**Subject:** License Amendment Request to Revise Technical Specification Figures 3.4.9-1, 3.4.9-2, and 3.4.9-3 to Replace Cycle Restriction with Effective Full Power Year Limitation  
Cooper Nuclear Station, Docket No. 50-298, DPR-46

**License Amendment Request to Revise Technical Specification Figures 3.4.9-1, 3.4.9-2, and 3.4.9-3 to Replace Cycle Restriction with Effective Full Power Year Limitation**

**Cooper Nuclear Station, NRC Docket 50-298, DPR-46**

**ATTACHMENT 2**  
**PROPOSED TECHNICAL SPECIFICATION REVISIONS**  
**(MARK-UP)**

Figure 3.4.9-1 (page 1 of 1)  
Pressure/Temperature Limits for  
Non-Nuclear Heatup or Cooldown Following Nuclear Shutdown  
Valid Through ~~End of Cycle 28~~

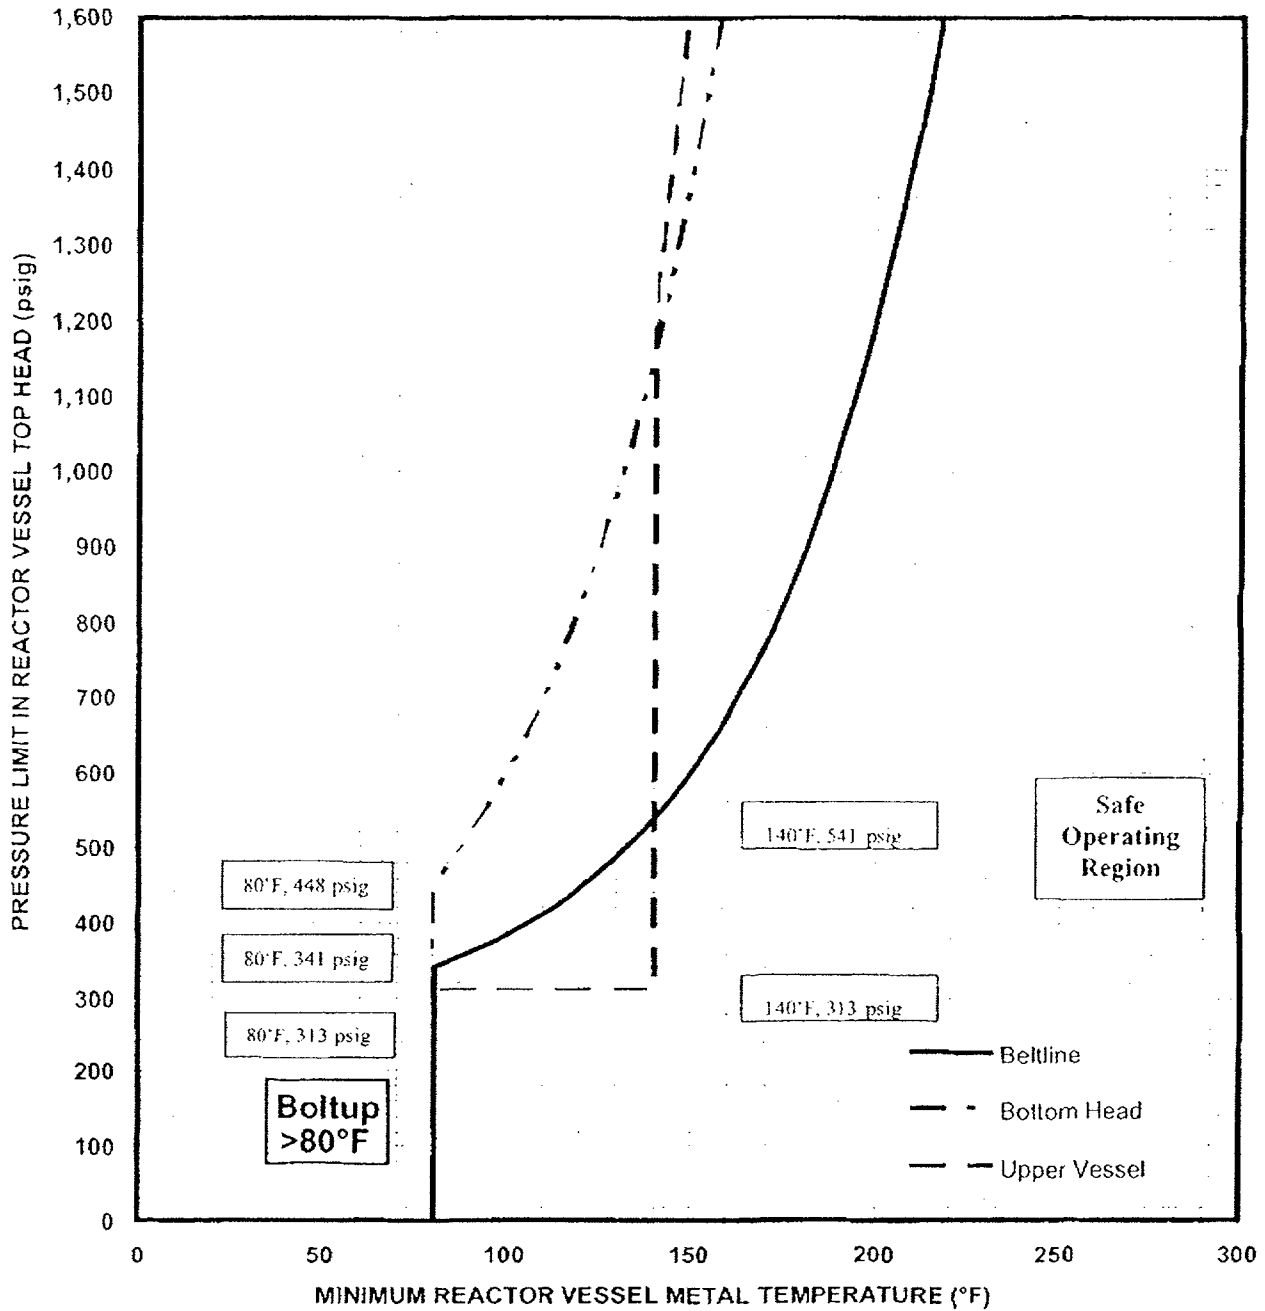
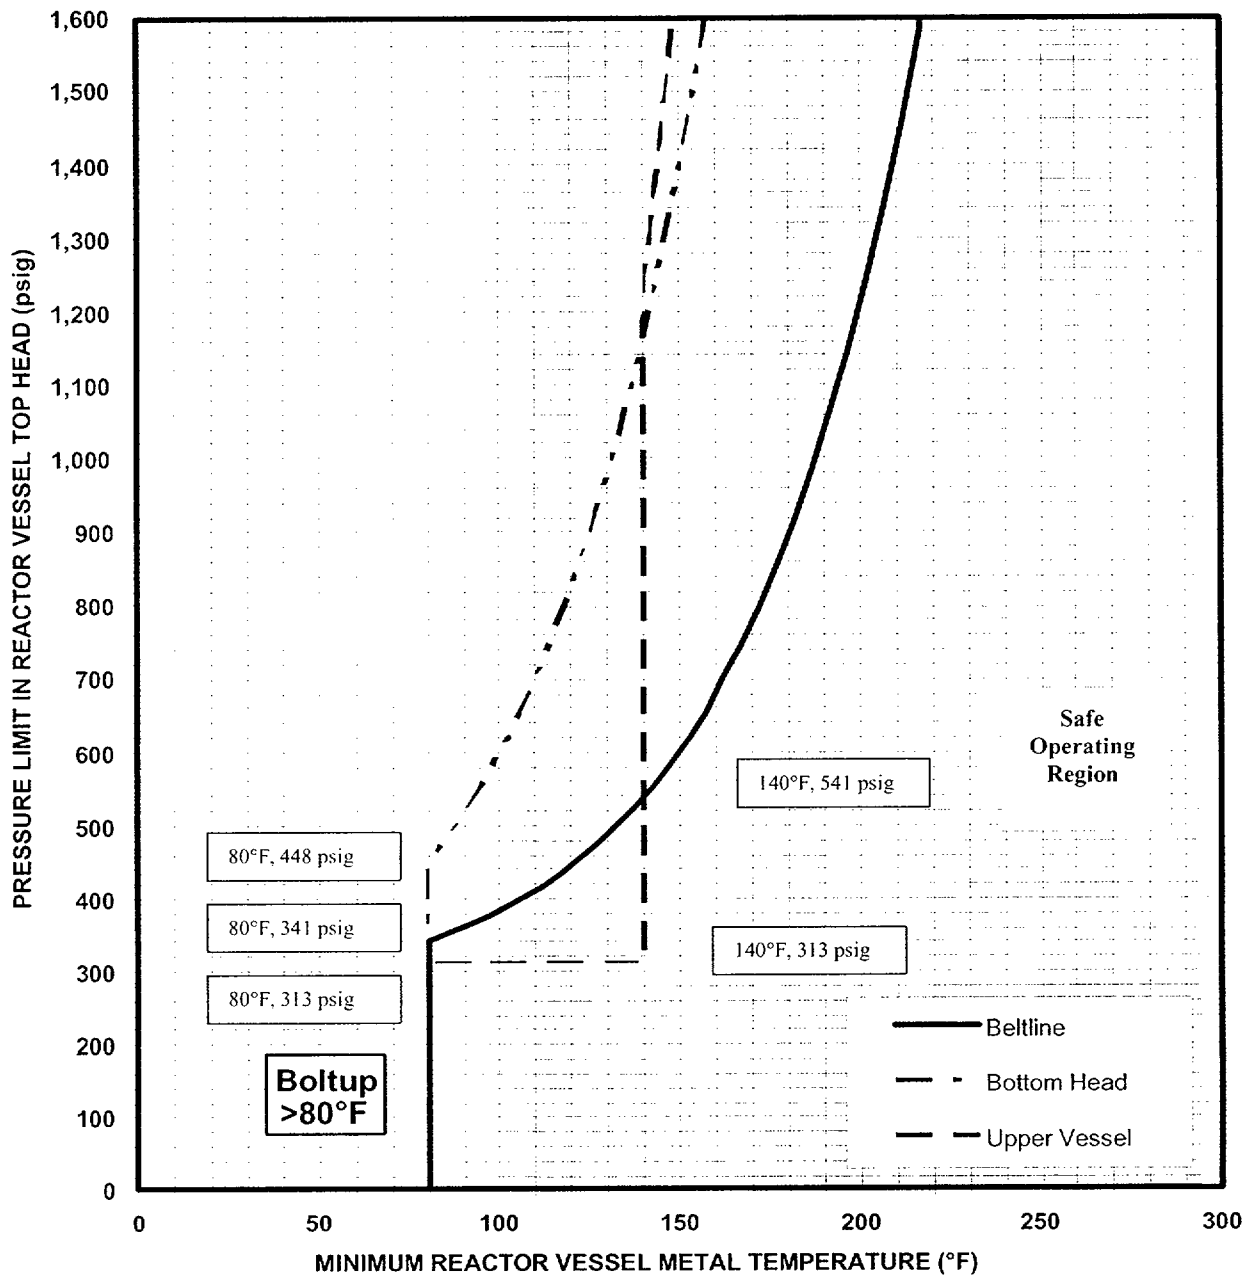
1. On TS Figure 3.4.9-1, "Pressure/Temperature Limits for Non-Nuclear Heatup or Cooldown Following Nuclear Shutdown, 32 EFPY," in the title change "32" to "30" and at the bottom change "End of Cycle 23" to "30 EFPY."
2. On TS Figure 3.4.9-2, "Pressure/Temperature Limits for Inservice Hydrostatic and Inservice Leakage Tests," in the title change "32" to "30" and at the bottom change "End of Cycle 23" to "30 EFPY."
3. On TS Figure 3.4.9-3 "Pressure/Temperature Limits for Criticality," in the title change "32" to "30" and at the bottom change "End of Cycle 23" to "30 EFPY."

The maximum beltline fluence calculated in NEDC 05-019 is slightly higher than the fluence used in the generation of the current P/T curves. Therefore, the P/T curves should be limited to 30 EFPY:  $[(1.57\text{E}18 \text{ n}/\text{cm}^2)/(1.67\text{E}18 \text{ n}/\text{cm}^2) * 32 \text{ EFPY} = 30.1 \text{ EFPY}]$ .

The "End of Cycle 23" limitation on the existing P/T curves in the TS may be removed and replaced with a limit of 30 EFPY. 30 EFPY is conservative because it is less than the 30.1 EFPY in the calculation.

Figure 3.4.9-1 (page 1 of 1)  
 Pressure/Temperature Limits for  
 Non-Nuclear Heatup or Cooldown Following Nuclear Shutdown  
 Valid Through 30 EFPY
